RE: NOV #85-4-15-1, Abatement Response Plans received on September 20, 1985, Soldier Creek Coal Company, Soldier Canyon Mine, ACT/007/018

Soldier Creek submitted abatement plans in response to a violation concerning failure to construct sediment pond according to approved mine plans. These abatement plans modify the existing plan by placing additional riprap material on the toe of the outslope of the sediment pond and in the perennial stream channel.

PROJECT NAME SOLDIER CREEK SEDIMENT POND - R. HARDEN

SLOPES 6 SLOPE STABILITY ANALYSIS
INPUT DATA GRAPHICAL PRINTOUT

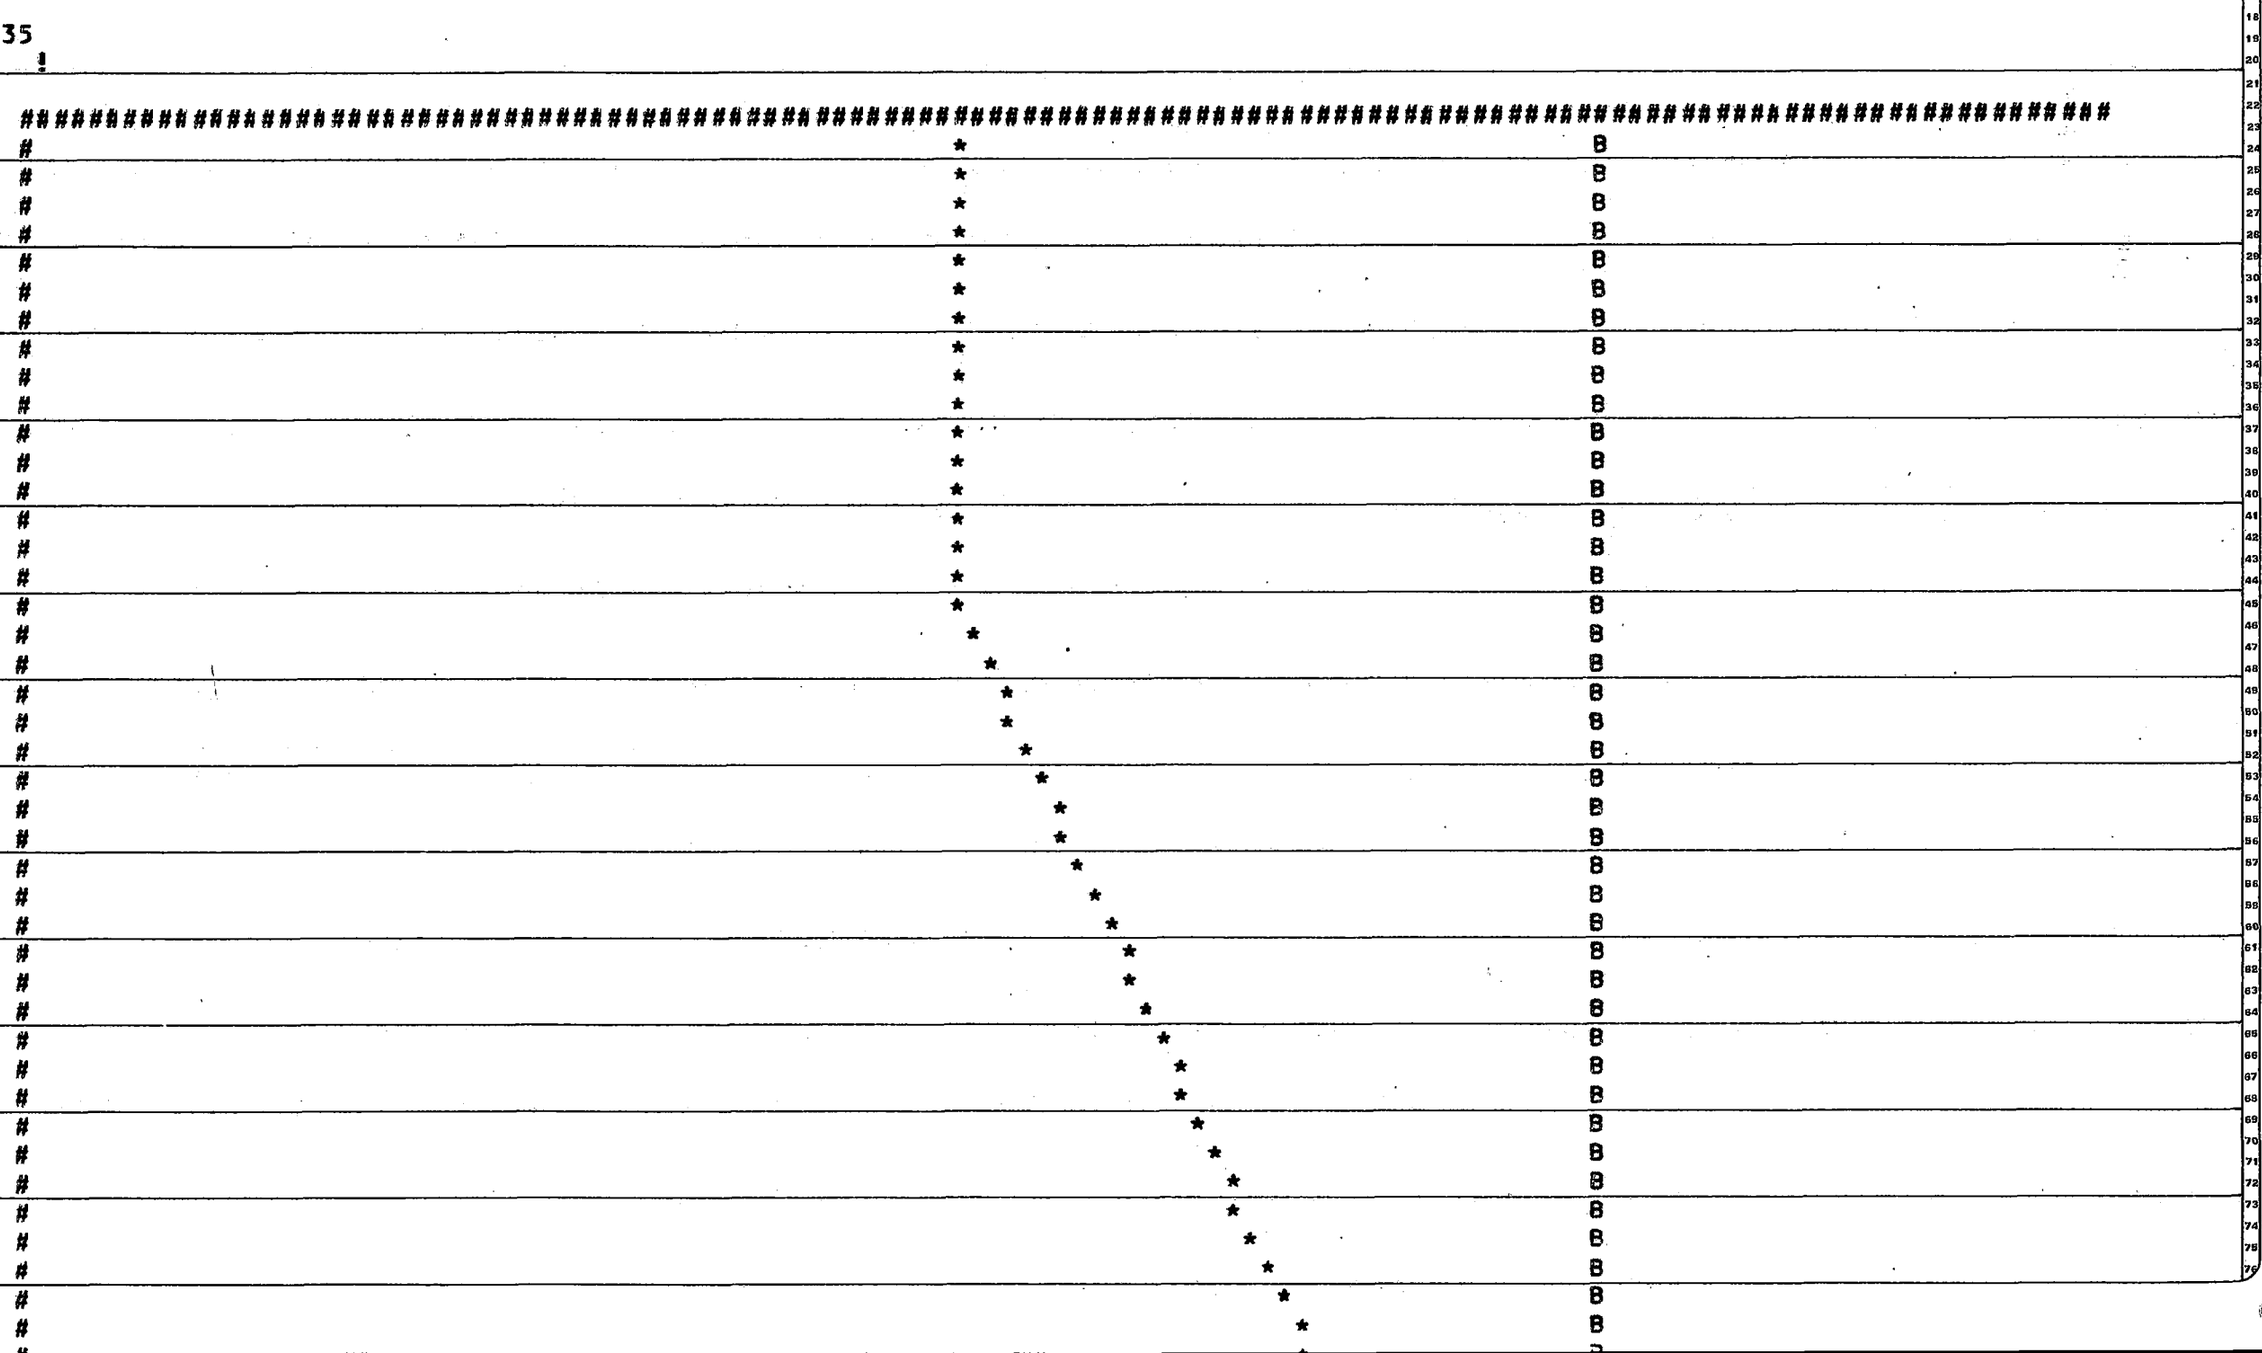
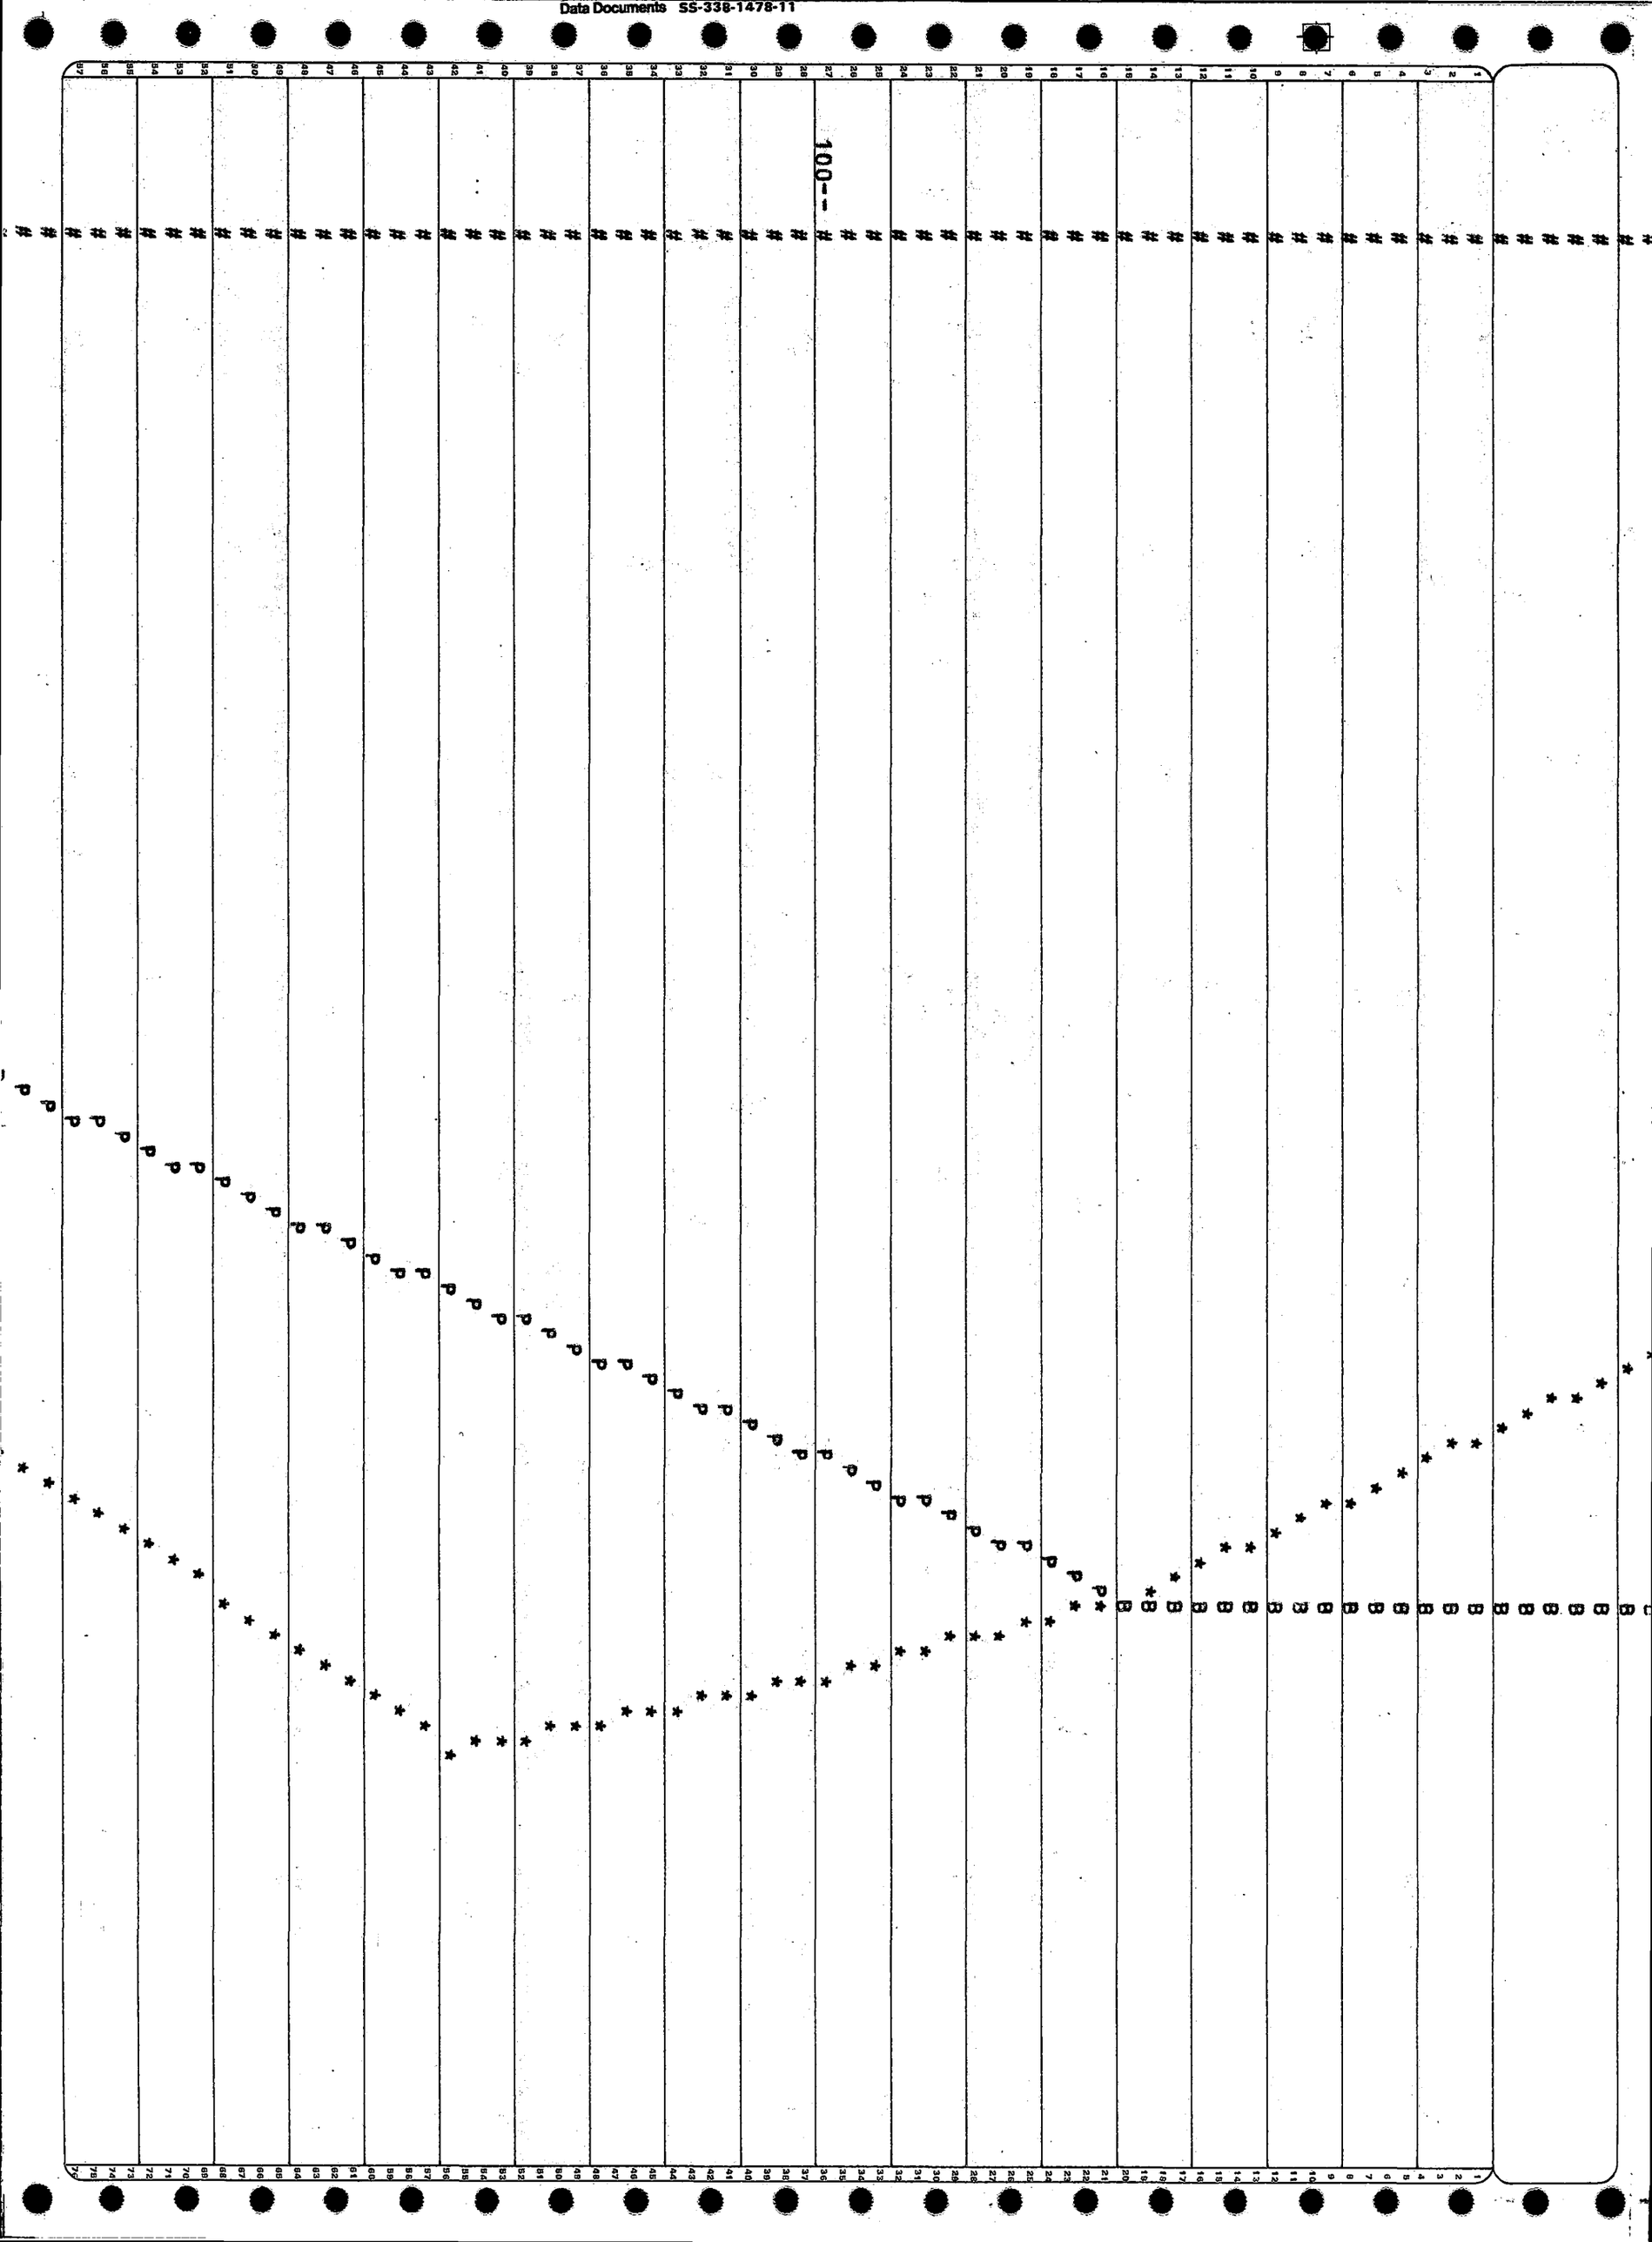
3. Calculations for the stability of the sediment pond are not sufficient to show stability. Calculations by the Division indicate that the proposed has a factor of safety which is considerably less than 1.5. Design of embankments, including the opposite stream channel, must be revised and complete stability analysis of the embankments must be provided to ensure stability of 1.5 static.

Calculations regarding the stability of the sediment pond and stream channel embankments are as attached to this memo(computer printouts).
